STAFF REPORT

SUBJECT: H-2020-0088
Baraya Subdivision No. 5

Final Plat consisting of 61 building lots and 10 common lots on 12.38 acres of land in the R-15 zoning district for the fifth phase of Baraya Subdivision.

C. Final Plat (date: 9/22/2020)

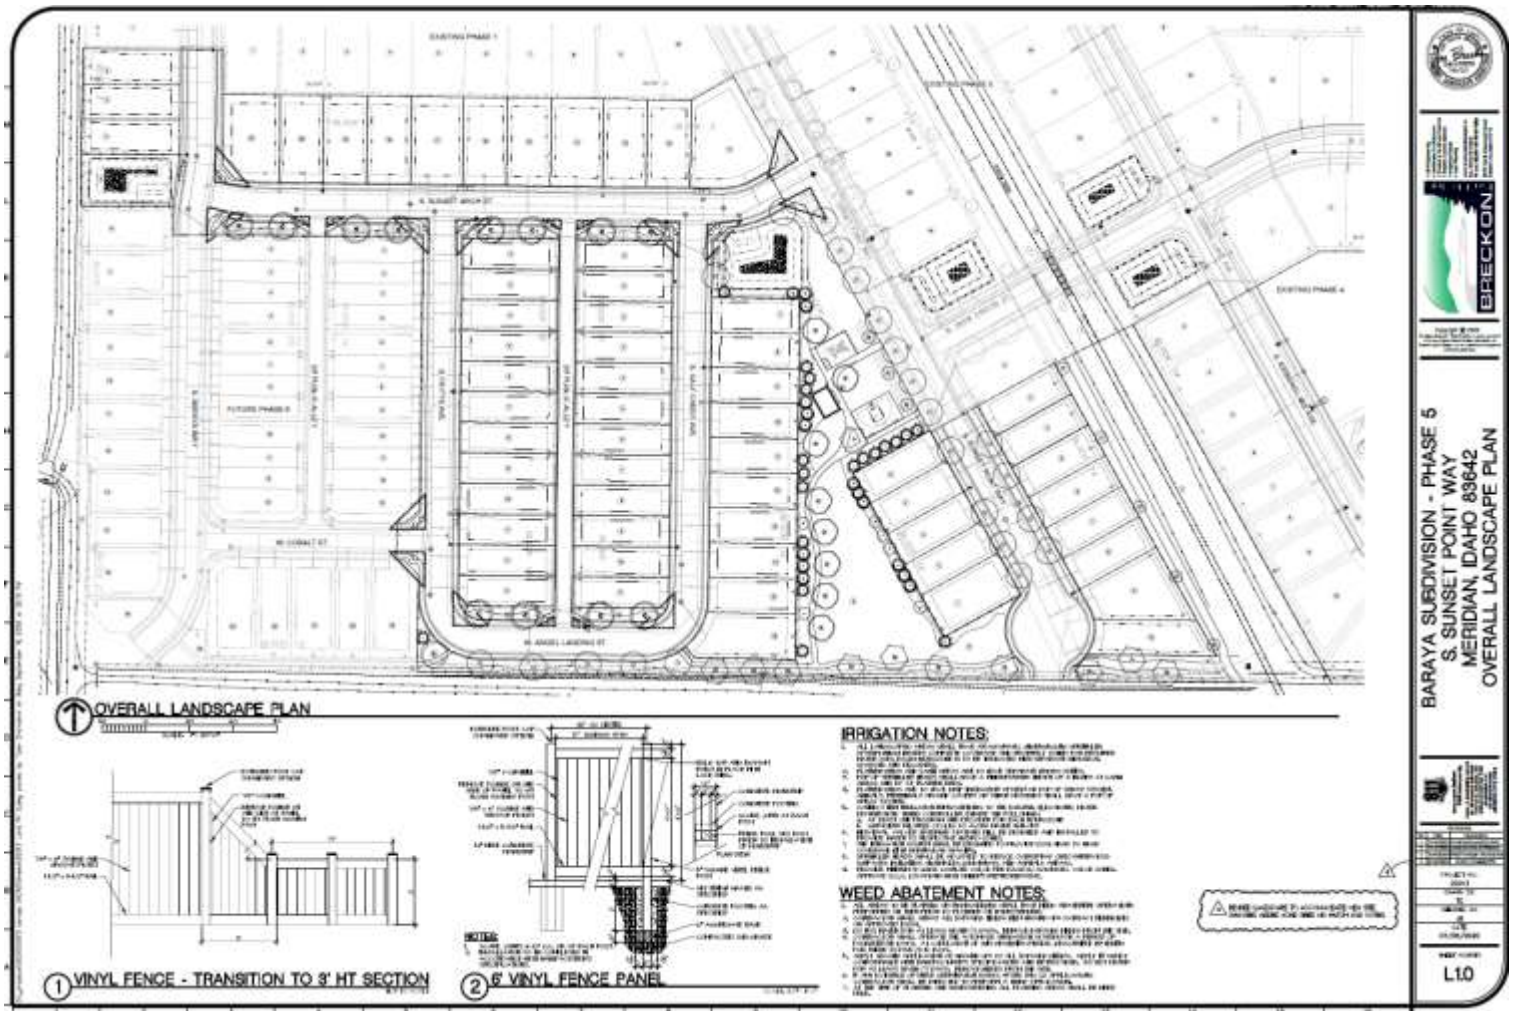
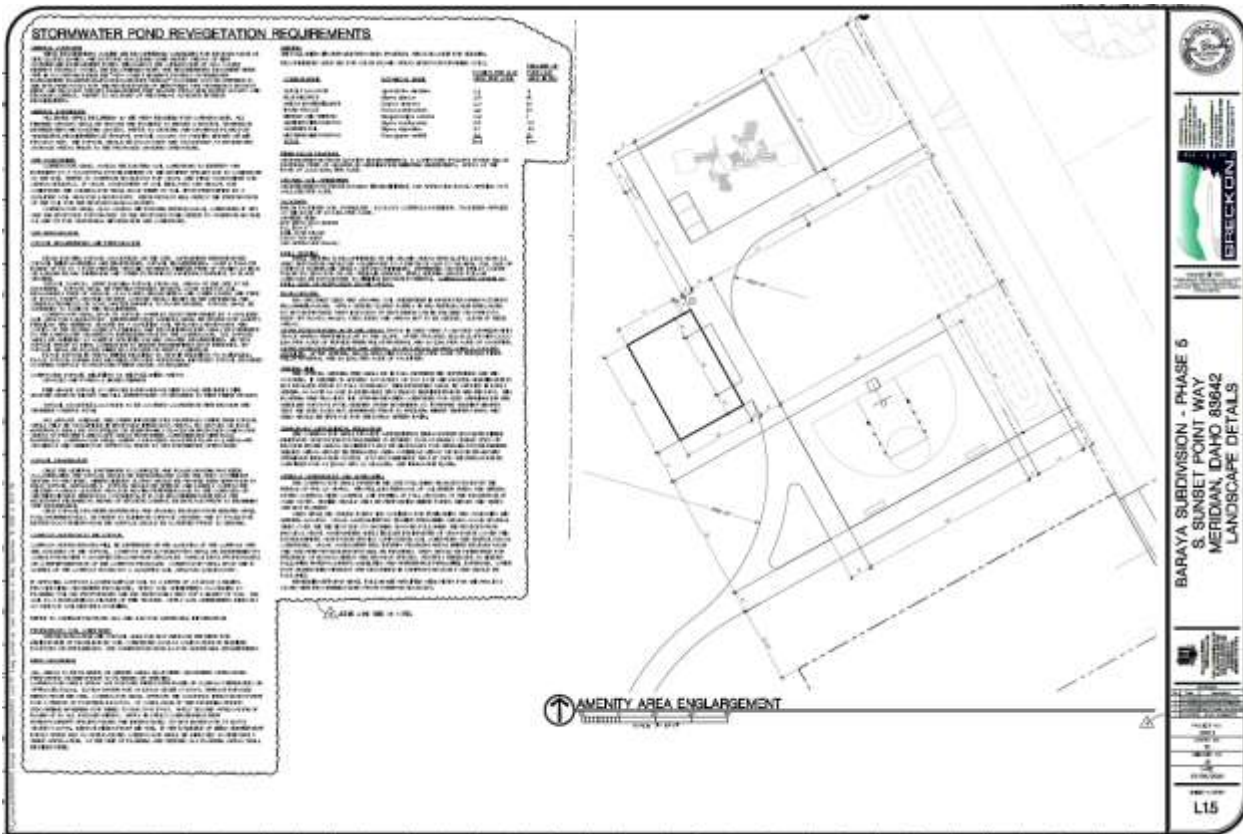
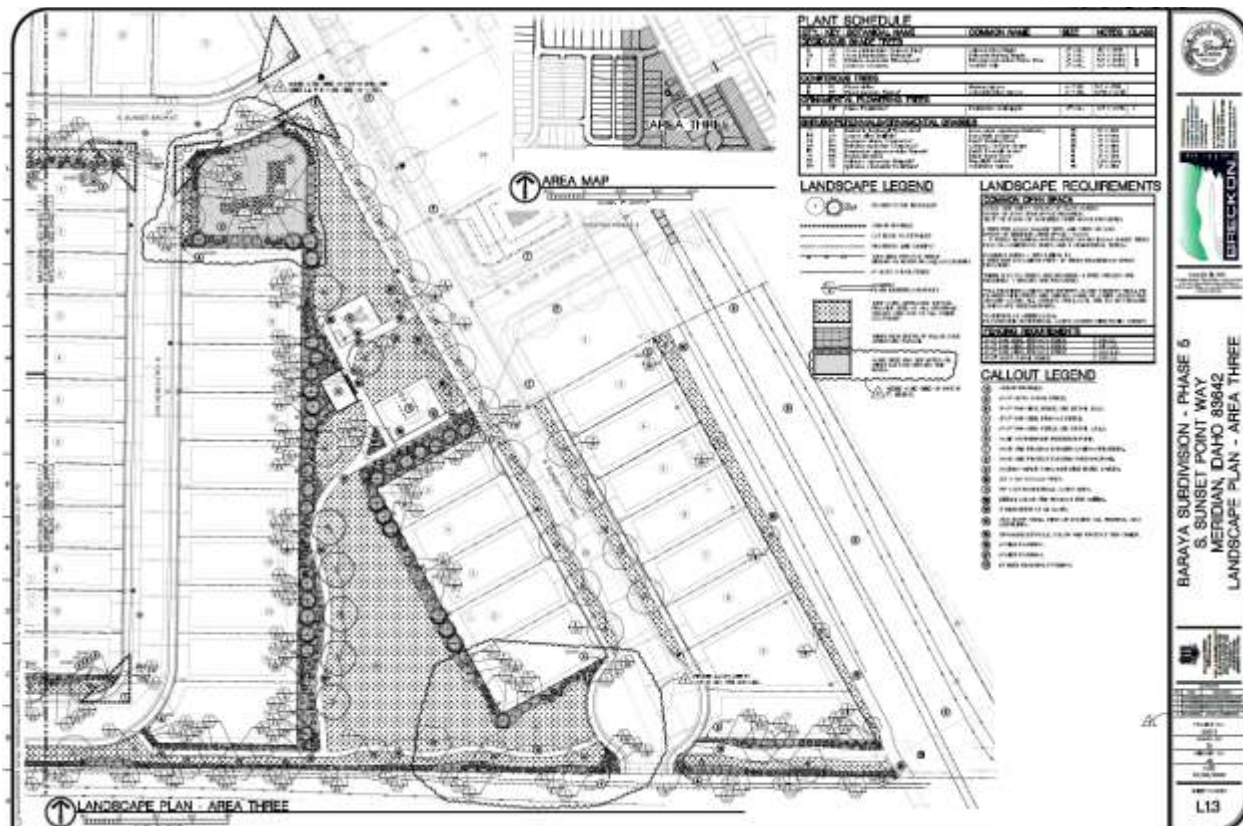
3. Prior to submittal for the City Engineer's signature, have the Certificate of Owners and the accompanying acknowledgement signed and notarized.
4. The final plat prepared by Bailey Engineering, Inc. stamped on 9/22/2020 by Gregory G. Carter, shall be revised as follows:

- a. Note #2: ". . . Lot ~~40~~11, Block 14, Lot ~~7~~6, Block 16 . . ."
 - b. Note #3: ". . . Lot ~~7~~6, Block 16 . . ."
 - c. Note #9: Include the recorded instrument number for the NMID pump station operation and maintenance agreement.

- d. Note #10: Include the recorded instrument number or the ACHD License Agreement.
 - e. Note #11: Include the recorded instrument number for the ACHD Permanent Easement.

- f. Note #14: "Lot ~~40~~11, Block 14 contains a blanket easement . . ."
 - g. Note #15: Include the recorded instrument number of the pathway easement.

D. Landscape Plan (dated: 9/16/20) & Playground Equipment Detail

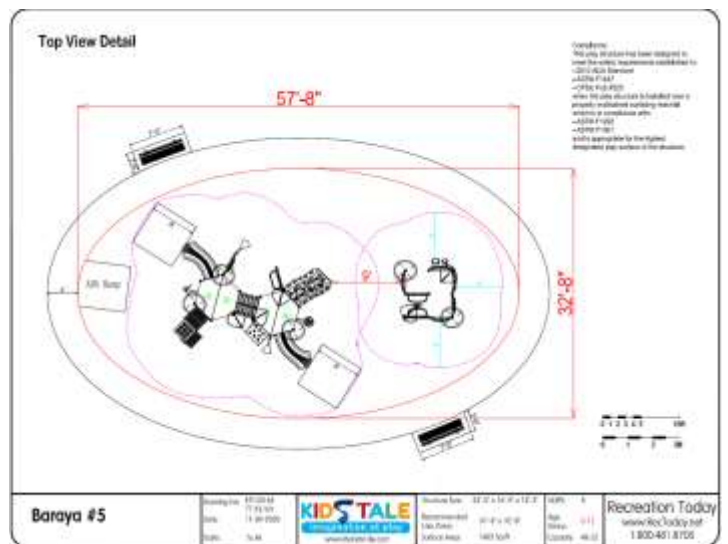
5. The landscape plan prepared by Breckon Land Design, dated 9/16/20, shall be revised as follows:
 - a. Include a detail for the 6-foot tall vista 3-rail fence proposed adjacent to the common area on Lot 11, Block 14 that contains a pathway and the Purdam Drain.

- b. Depict fencing (chain-link or wrought iron) between the multi-use pathway and the Purdam Drain for public safety as proposed by the Applicant and depicted on the landscape plan approved with the preliminary plat.

- c. Depict a 5-foot wide landscape strip along the east side of the multi-use pathway along the Purdam Drain, landscaped per the standards listed in UDC 11-3B-12C.
